HURRICANE CITY UTAH

Hurricane Planning Commission Meeting Agenda

November 10, 2022
5:00 PM

ZONE CHANGE EXHIBIT FOR: CADENCE ACTIVE ADULT COMMUNITY

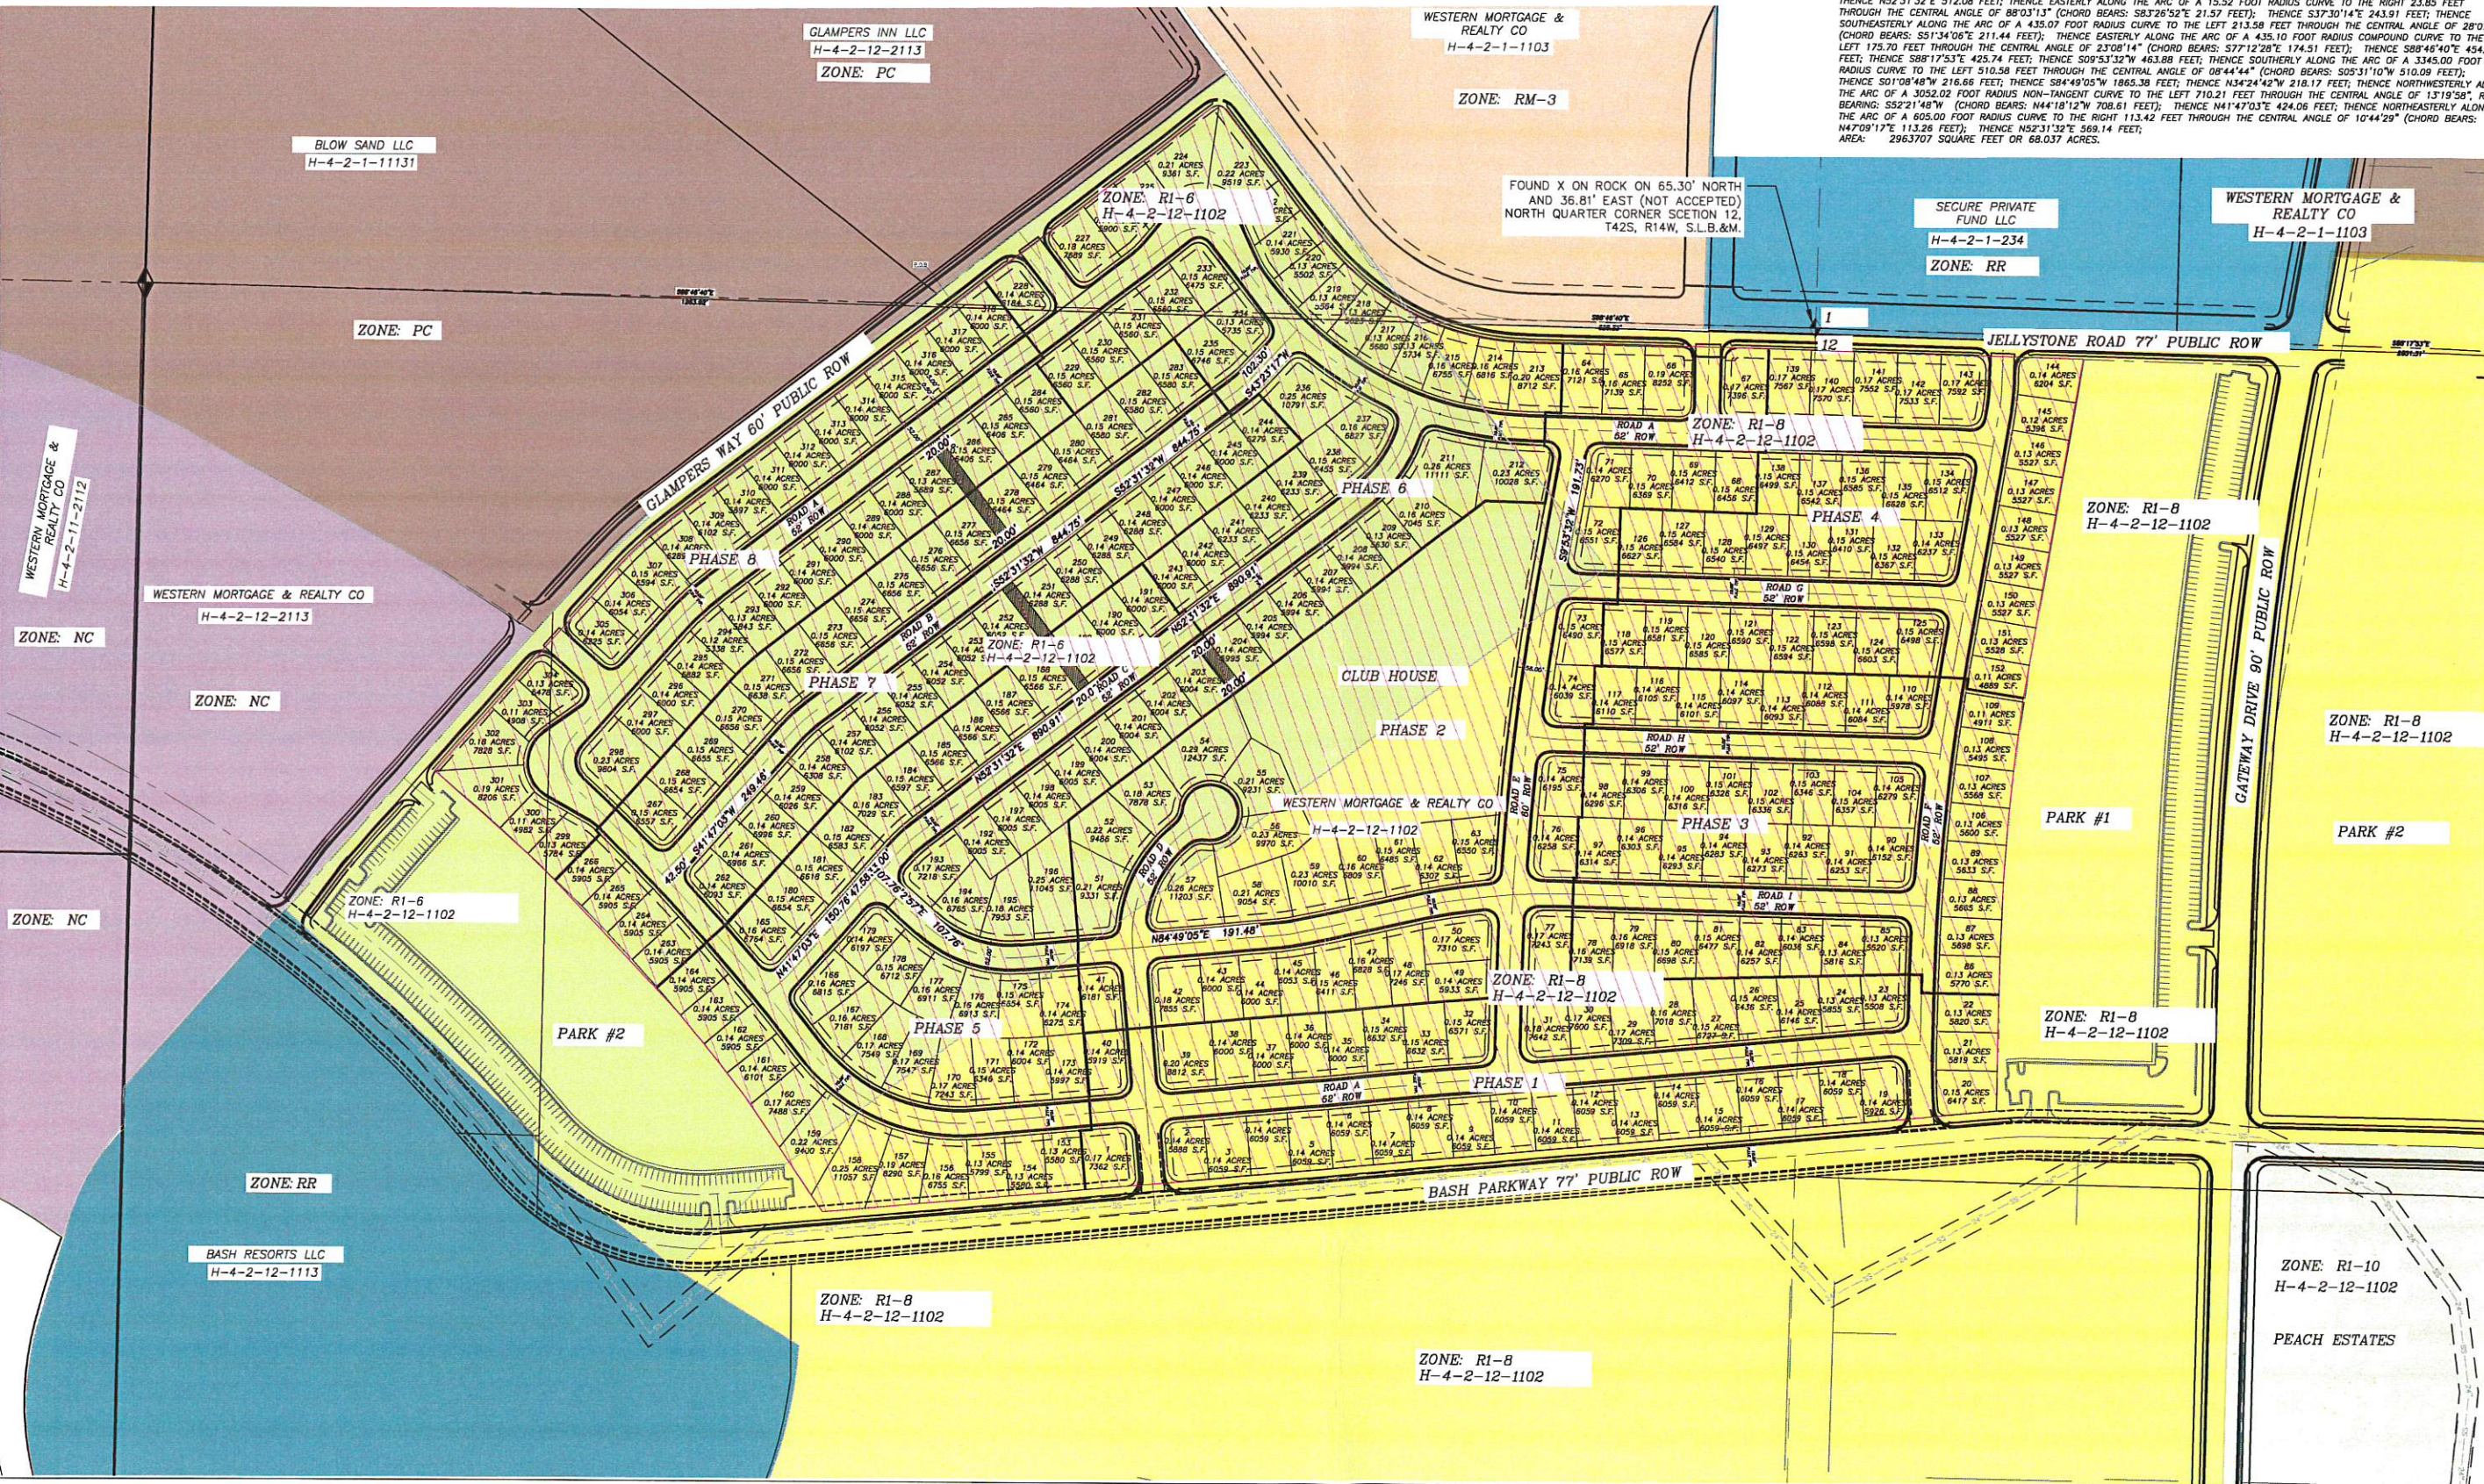
1. **Public Works:** The PID will need to put in all major infrastructure before construction can begin
2. **Power:** Dixie Power area. Working with the PID to get power to the location. No infrastructure in the area at this time. There will need to be a new substation in the area with pulse transmission lines
3. **Sewer:** Matches plans PID has submitted thus far
4. **Streets:** Will need streets to access the property put in
5. **Water:** Will need to get water to the area. Will need a water model
6. **Engineering:** PID has yet to submit construction drawings for the two parks. The roads to the area will need to be completed before they can begin construction
7. **Fire:** Will need all utilities to be complete to meet fire code
8. **Gas:** No access yet but otherwise have no concerns

2. **Parking:** Site plan does not indicate whether mapped parking will be sufficient. However, there are large parking areas to the east and southwest of the property that will most likely be sufficient for guests and other parking.

6. There are two parks located on the property that are planned to be regional stormwater facilities. These are planned to be improved and constructed through the PID. However, the PID has not submitted plans for these facilities at this time.

7. The applicant has provided a Clubhouse/Open Space area for the residents of this development. In addition, they have provided trails that link to the development. A trail should be added at the end of the cul-de-sac to provide better pedestrian access.

8. Several of the roads on the north of the development are longer than the 800' maximum; another roadway should be added to divide up the blocks where needed.

Recommendation: Staff recommends the Planning Commission review this application and the zone change based on standards and consider residents' comments. Staff would recommend that the Planning Commission approve the zone change and PDO conditioned on sufficient buildout of the Sand Hollow PID.

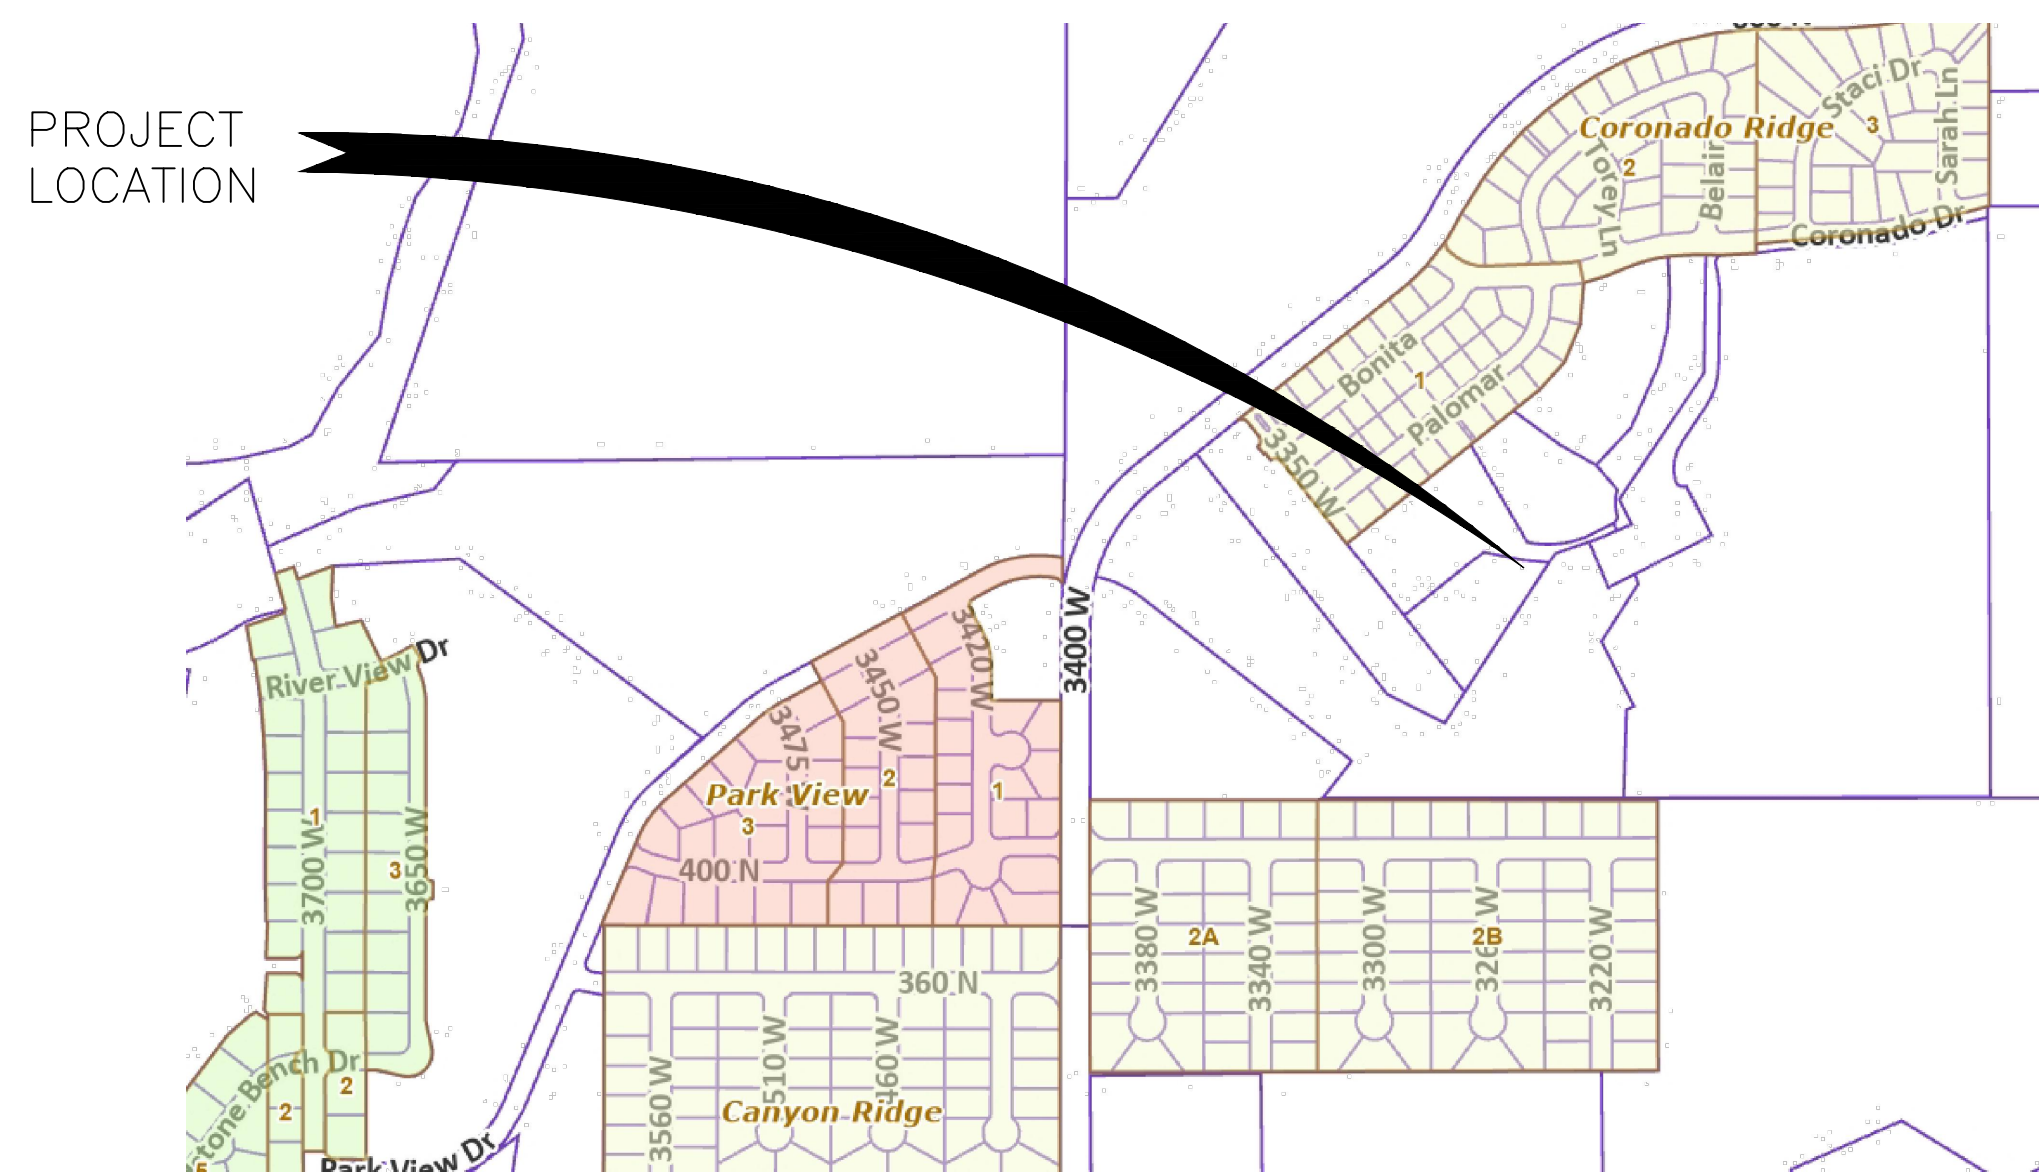
Many of the lots along the center of the property are located on property that is 10%-20% slope. The applicant will need to provide the slope of each lot based on the City code and a full grading plan that justifies any type of exception.

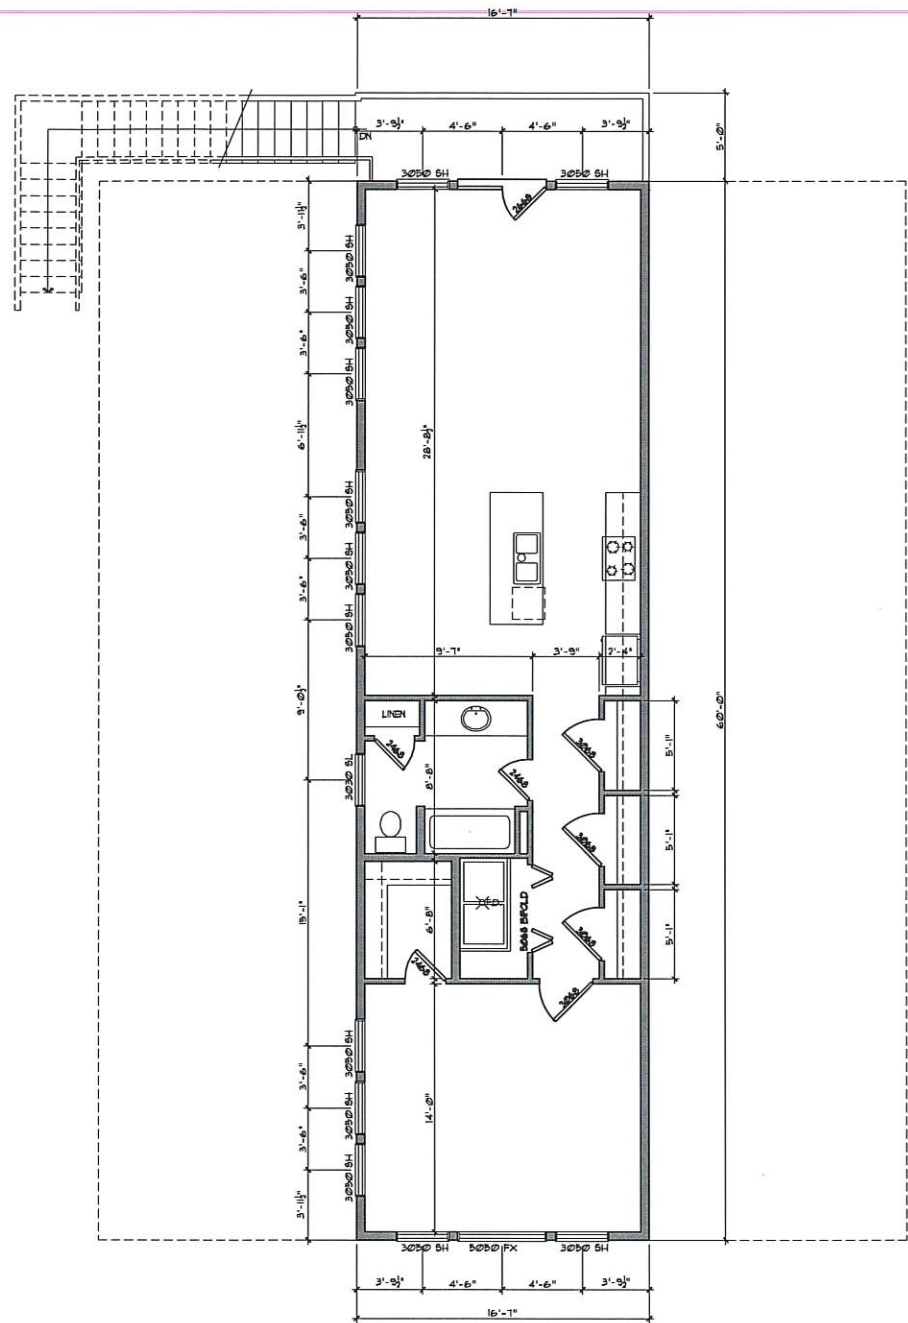
Stairs shall meet the requirements of 2015 IRC R311

WEST ELEVATION
SCALE: 1/4" = 1'-0"

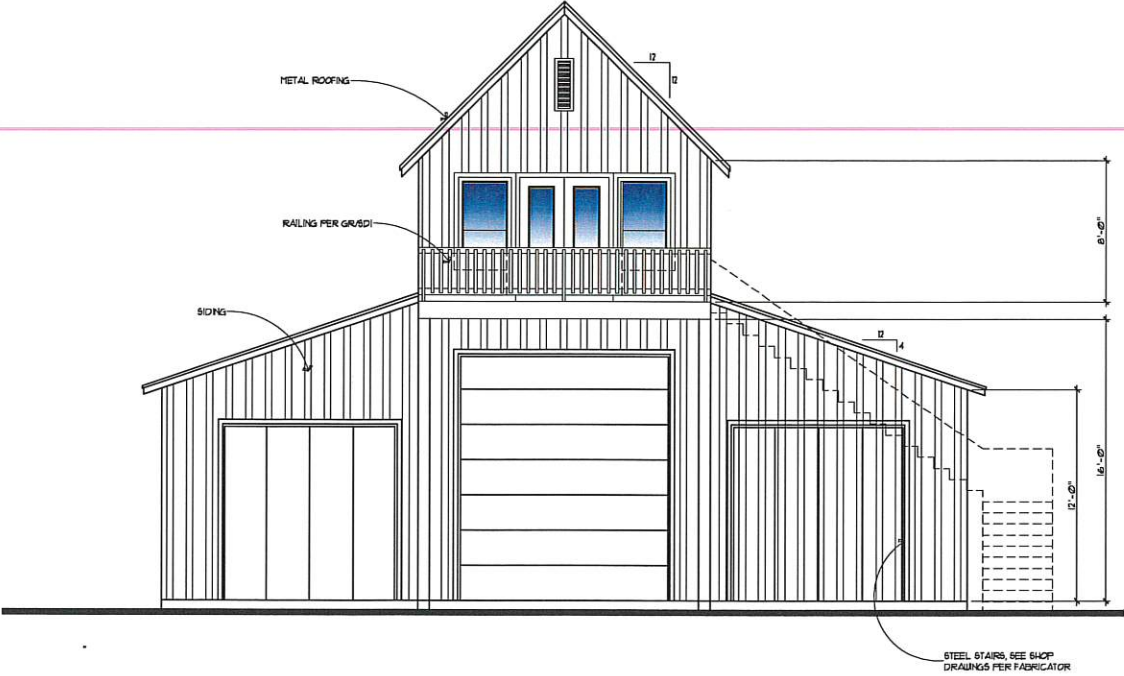
REVIEWED FOR CODE COMPLIANCE
10/14/2022
R. WYMAN

EAST ELEVATION
SCALE: 1/4" = 1'-0"

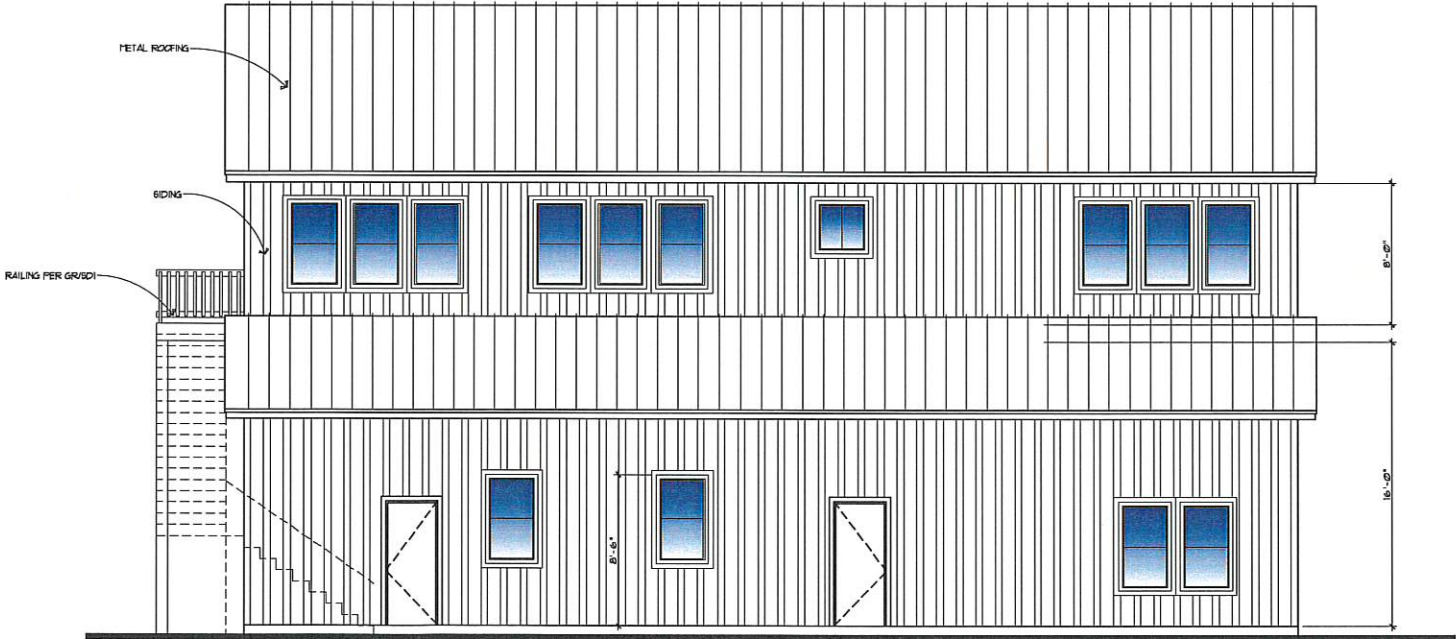
Guards are required for walking surfaces exceeding 30" above adjacent grade.
They shall have minimum height of 36". No openings larger than a 4" sphere.
Stair toe kick opening shall not exceed 4". Triangular stair opening shall not exceed 6".

Roofs are required to be ventilated per 2015 IRC R806.2
